To: Development Permit Panel

File: DP 12-600815

Re: **Application by IBI-HB Architects for a Development Permit at
8380 Lansdowne Road**

SECTION AT STEPPED PLANTER ADJACENT TO NEIGHBOUR PROPERTY

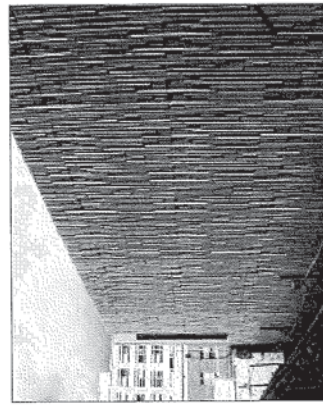
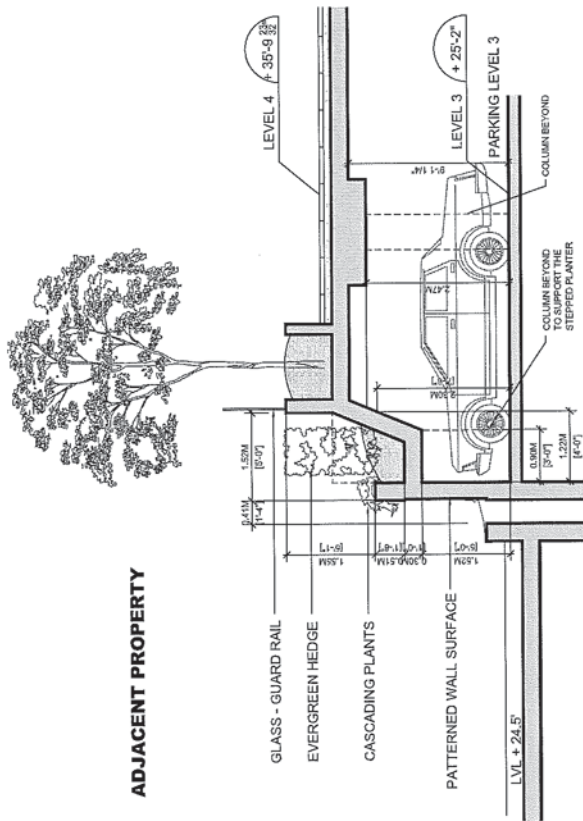
- space between the podium level of the adjacent building and higher podium of the subject development is not welcoming; space between these two podiums with a 12-foot height differential appears dark; consider incorporating public art at adjacent property where this project creates a canyon-like space to make it a more invigorating space; *(Please see revised section through the west wall adjoining the neighbor and the revised landscape plan. The west wall height is further reduced and is treated with textured pattern treatment and stepping planters along the top line)*

EAST ELEVATION

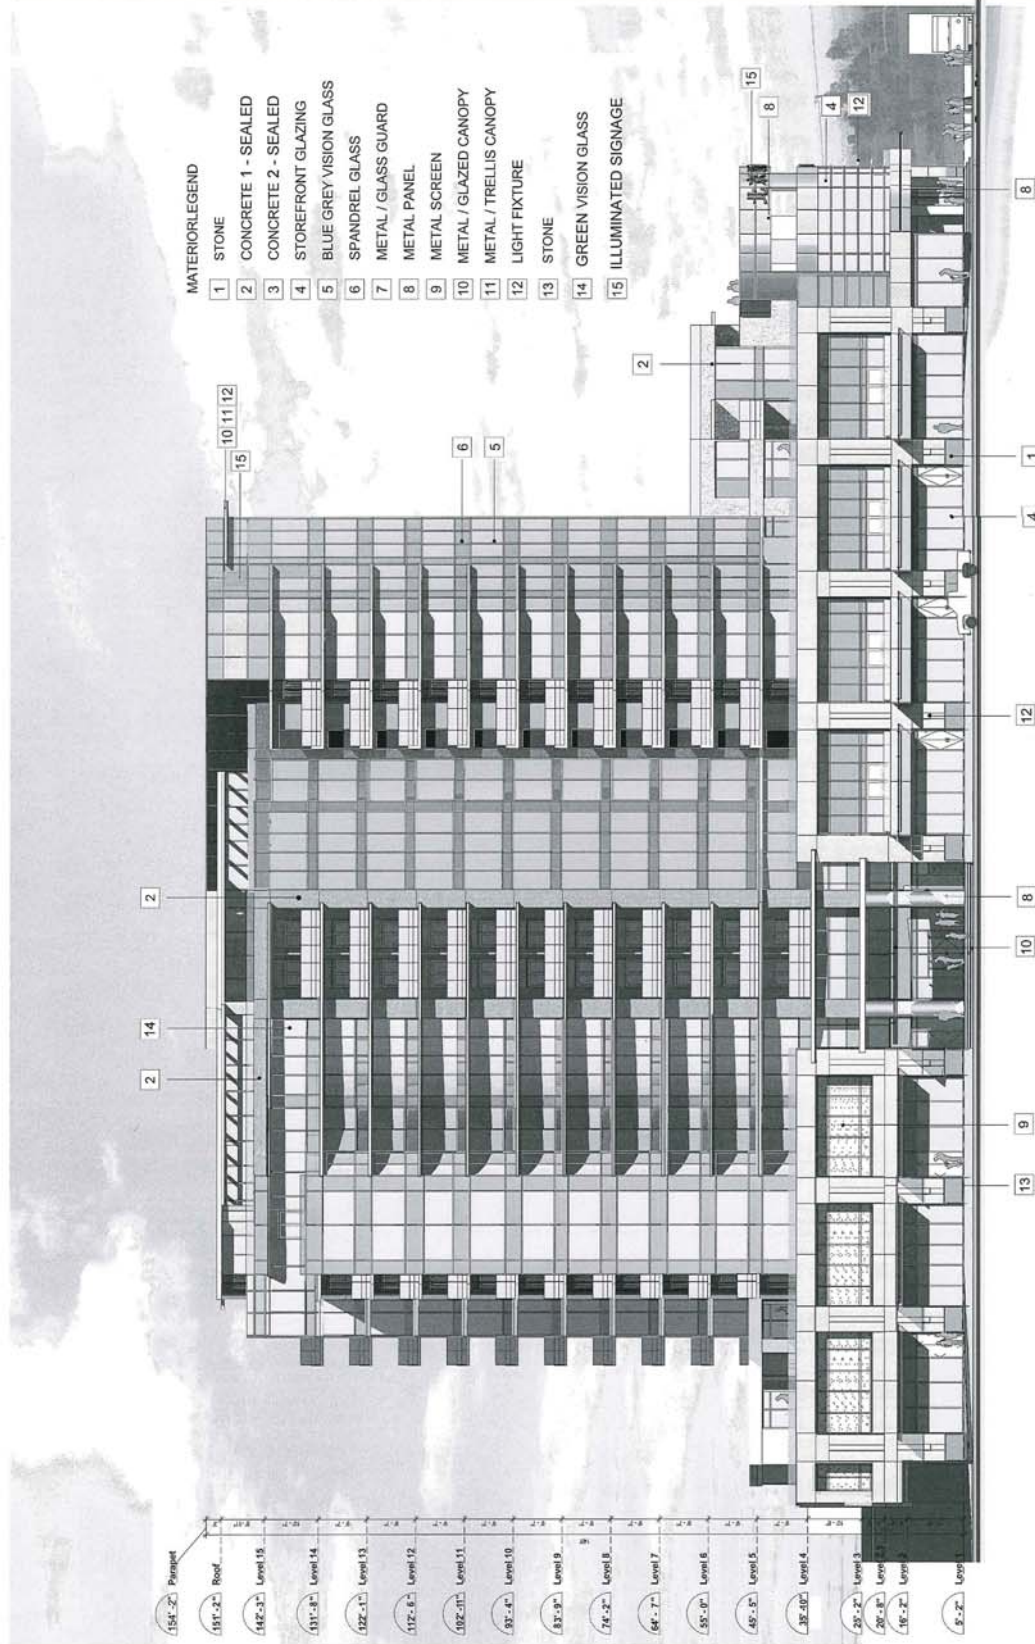
- consider increasing the height of angled tower corner element adjacent the intersection to give it more prominence; *(Please see revised elevations. The parapet of east elevation is lowered 1'6" to make the corner higher than the rest of the parapets. Further, an eyebrow canopy returning from the north balcony canopy to the east elevation is provided to enhance the prominence of the tower corner and give a cap effect to the tower top)*

- tower appears flat and chunky; consider stepping down the angled tower element to break up the tower; *(Please see revised elevations. The parapet of east elevation is lowered 1'6" to make the corner higher than the rest of the parapets. Further, an eyebrow canopy returning from the north balcony canopy to the east elevation is provided to enhance the prominence of the tower corner and give a cap effect to the tower top)*

- shape of the tower needs more articulation; improvement in design is needed in view of the importance of the corner, e.g. by adding a vertical element that comes down; *(Please see revised elevations. The parapet of east elevation is lowered 1'6" to make the corner higher than the rest of the parapets. Further, an eyebrow canopy returning from the north balcony canopy to the east elevation and adjacent building signage panel provided enhance the prominence of the tower corner and give a cap effect to the tower top. A vertical line of lighting along the northeast corner line and top eyebrow canopy may be introduced in consultation with the public artist as part of the public art component; this may well tie in with the lighting feature at the podium round corner element)*

- tower is quirky and does not meet the ground well at the main entry on Cooney Road; applicant needs to address the residential entrance at Cooney Road in a stronger way; appears weak at present; *(Please see revised east elevation and the detail drawings showing the glazed metal canopy highlighting the building's main entrance)*

SECTION AT STEPPED PLANTER ADJACENT TO NEIGHBOUR PROPERTY

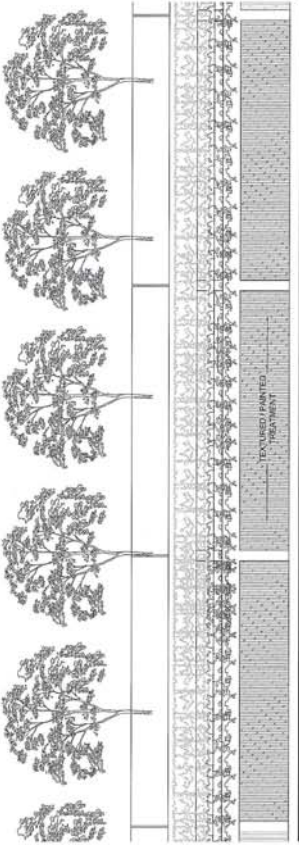
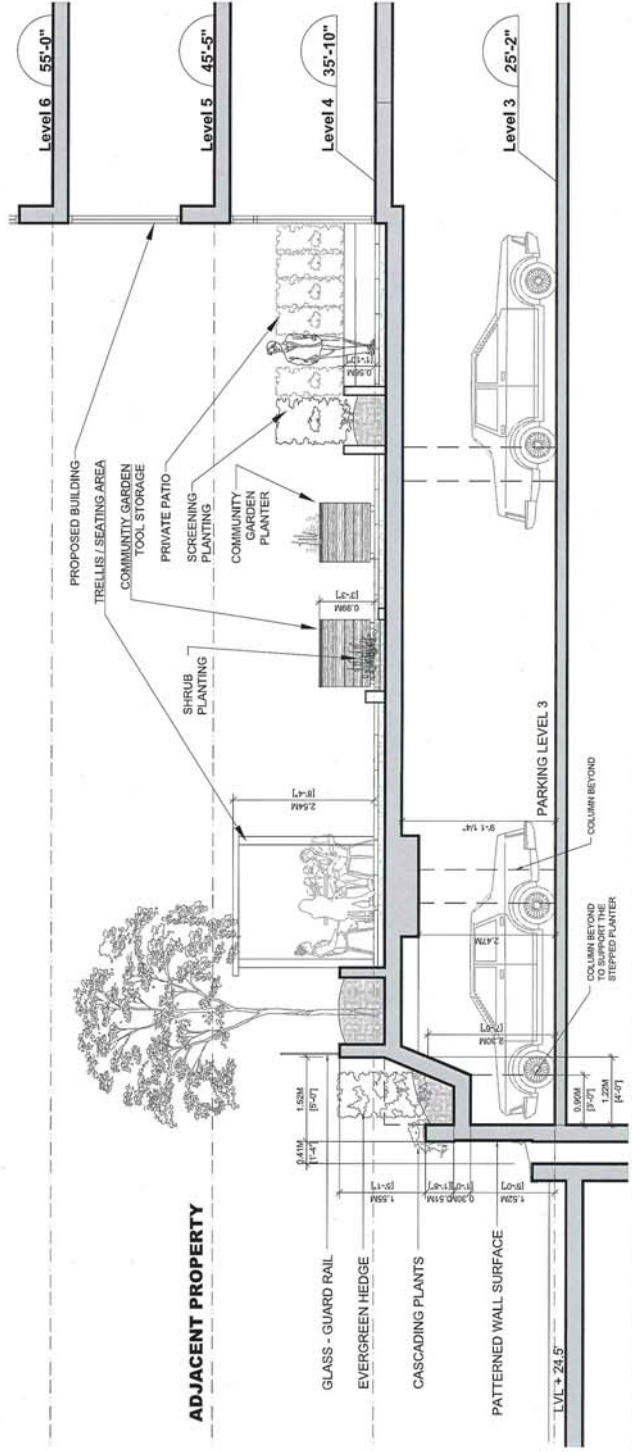
- The cascading type of planting in the terraced landscaped planters along the west side of the podium reduce the perceived height and soften the west parkade wall (**Attachment 3**) that will be viewed from the lower level units in the adjacent building. In addition, a combination of textured and plain concrete treatment of this wall will provide some interest and variety to otherwise plain blank wall.
